DOCKET ITEM #14
Development Special Use Permit #2017-0017
Encroachment #2018-0004
3030, 3050 Potomac Avenue, and portion of 3601 Jefferson
Davis Highway – American Physical Therapy Association

Application	General Data	
Project Name: American Physical Therapy Association - Potomac Yard Landbay G, Block A – Building A1	PC Hearing:	June 5, 2018
	CC Hearing:	June 23, 2018
	If approved, DSUP Expiration:	Pursuant to Zoning Ordinance, Section 11-418, Time of Validity.*
	Plan Acreage:	0.6097 Acres (26,558 SF); 0.6646 Acres (28,949 SF) w/Part Parcel 525
Location: 3030 Potomac Avenue <i>(Landbay G, Block A)</i> 3050 Potomac Avenue <i>(Outlot A)</i> 3601 Jefferson Davis Hwy <i>(Part Parcel 525)</i>	Zone:	CDD#10
	Proposed Use:	Office Use
Applicant: APTA Centennial Properties, LLC; represented by Cathy Puskar, Attorney	Small Area Plan:	Potomac Yard/Potomac Greens
	Historic District:	N/A
	Green Building:	Compliance with the City’s Green Building Policy

Staff Recommendation: APPROVAL WITH CONDITIONS
Staff Reviewers: Rob Kerns, AICP; Development Division Chief rob.kerns@alexandriava.gov Gary Wagner, PLA, ASLA; Principal Planner gary.wagner@alexandriava.gov Michael Swidrak, AICP; Urban Planner mi

Figure 6: Alternate Alignment, where Dogue Street wraps around the north of the site (left), and preferred alignment, where Wesmond Drive is routed along the northern border of Landbay G and intersects Potomac Avenue (right).

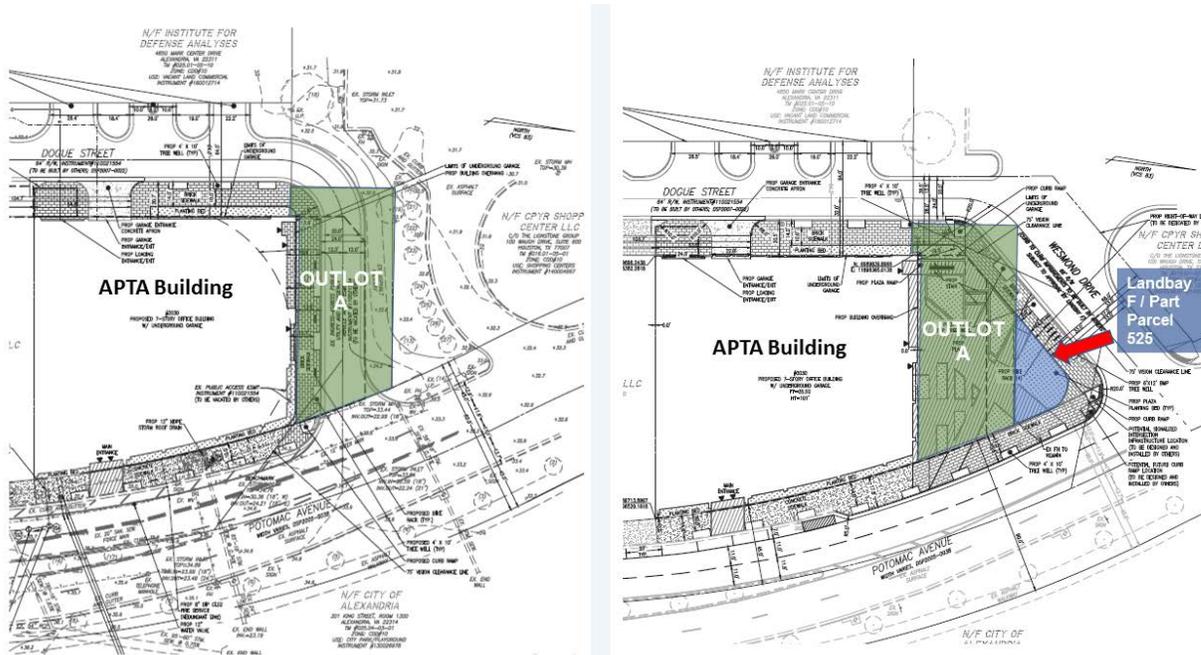
Further, the preferred alignment of Wesmond Drive is not yet reflected in the Landbay G Infrastructure Plan. However, JBG Smith, the developer of the Landbay G Infrastructure Plan, filed a Minor Site Plan Amendment application to reflect this preferred alignment of Wesmond Drive. This application is currently under review by staff and is running concurrent with the development application for APTA.

- i. In the preferred option shown on Sheet 4 of the preliminary site plan for Building A1, subject to all necessary City approvals and execution of all necessary easements, conveyances, dedications and/or agreements by the applicant and other necessary parties, Dogue Street shall be constructed curb to curb and operational including all associated street lights, street signs, underground utilities, and temporary asphalt sidewalks from Glebe Road to Wesmond Drive, and Wesmond Drive shall be constructed from Dogue Street to Potomac Avenue from face of southern curb to the limits shown on the revised infrastructure plan being processed by others. A public access easement over Wesmond Drive shall be provided prior to the release of the final site plan for Building A1 until such time that Wesmond Drive is dedicated to the City as public right of way by others.

- ii. In the event that the necessary easements, conveyances, dedications and/or agreements are not executed by the necessary parties prior to release of the final site plan for Building A1, then the alternate alignment of Dogue Street (Public) and Dogue Street (Private) on Outlot A shall be constructed and operational including all associated street lights, street signs, underground utilities, and temporary asphalt sidewalks from Glebe Road to Potomac Avenue as shown on Sheet 6 of the preliminary site plan for Building A1. A public access easement over Dogue Street (Private) shall be provided prior to the issuance of the final certificate of occupancy for Building A2, or prior to the release of the final site plan for Building A1 or Block D, whichever is first. At such time as Wesmond Drive between Dogue Street (Public) and Potomac Avenue is constructed by others, the applicant shall grant reasonable easements necessary for the construction of Wesmond Drive and the removal of Dogue Street (Private) on Outlot A.

Figure 7: Encroachment exhibit.

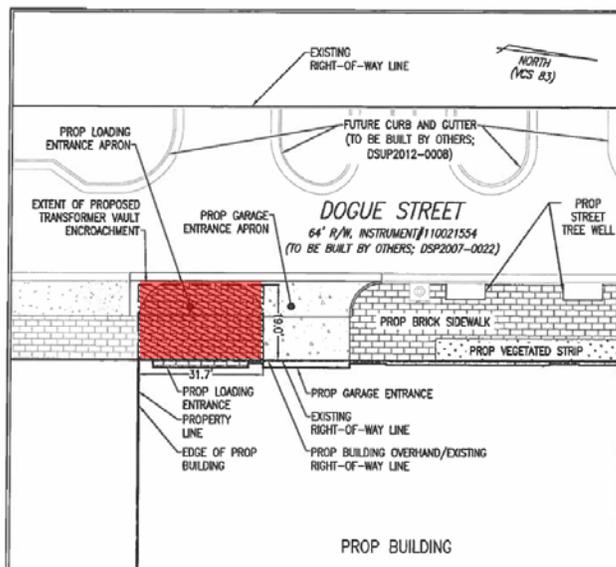
Staff does not object to the applicant’s request to install an electric transformer vault in the public right-of-way in the proposed location. The construction of the underground vault in the right-of-way for Dogue Street will facilitate necessary access for Dominion Virginia Power to service the vault. The ongoing DSUP conditions for Landbay G have already specified that transformer vaults “may be placed in the street right-of-way or in driveways.”

Constraints on placing the transformer vault on-site included its impedance in the design of the plaza, which will be private-owned but will function as a public space, and design issues with placing the vault in the area designated for the underground garage, which extends under most of the plaza area. As proposed, the vault hatch will be flush with the sidewalk and be covered with brick pavers to match the adjacent sidewalk areas. Staff has confirmed with an amendment to the conditions that the vault will be vented through the underground garage.
